ADDENDUM “A”

Request for Bids Bid #16-0226

Construction of Radio Communications Tower

RANDOLPH COUNTY
EMERGENCY
SERVICES
HEADQUARTERS

TK-101

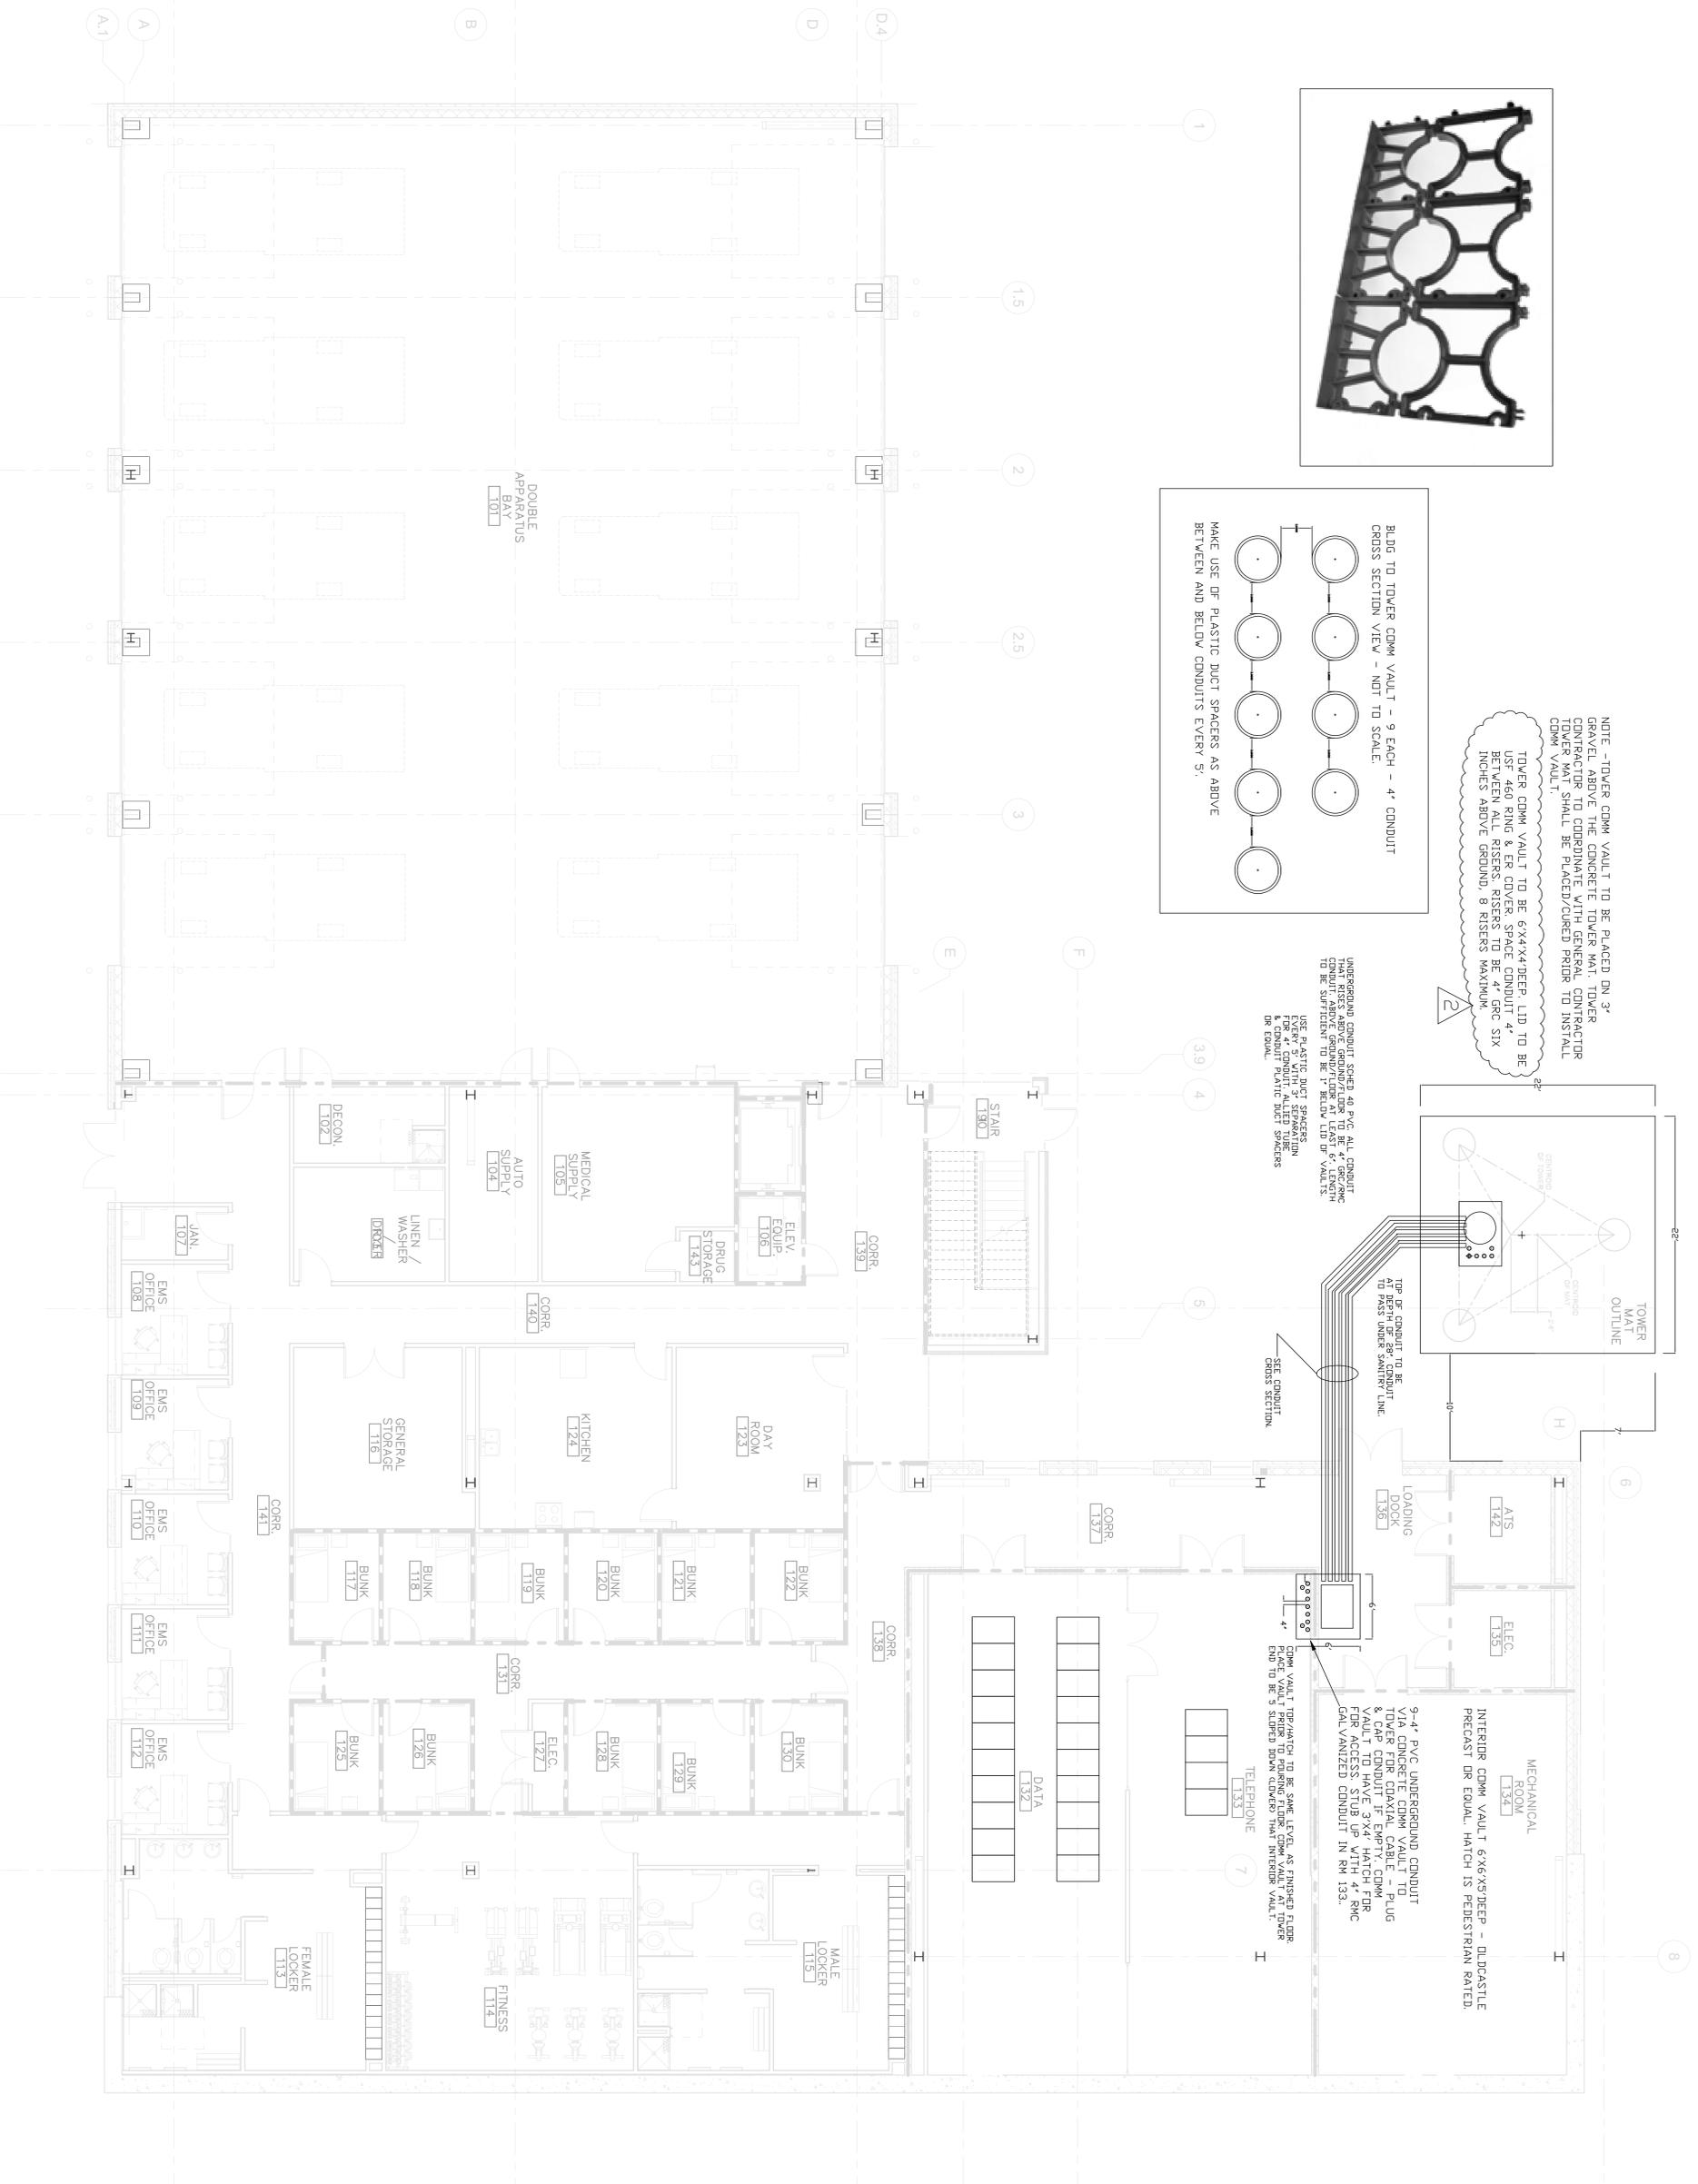
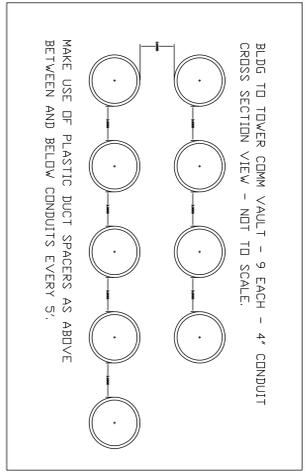
Revised Drawing #TK-101

Changed entry into comm vault to round USF460 ring and cover instead of the square. Does not affect tower location of tower installation.

NOTE -TOWER COMM VAULT TO BE PLACED ON 3" GRAVEL ABOVE THE CONCRETE TOWER MAT. TOWER CONTRACTOR TO COORDINATE WITH GENERAL CONTRACTOR TOWER MAT SHALL BE PLACED/CURED PRIOR TO INSTALL COMM VAULT.

TOWER COMM VAULT TO BE 6'X4'X4"DEEP. LID TO BE USF 460 RING & ER COVER. SPACE CONDUIT 4" BETWEEN ALL RISERS. RISERS TO BE 4" GRG SIX INCHES ABOVE GROUND, 8 RISERS MAXIMUM.
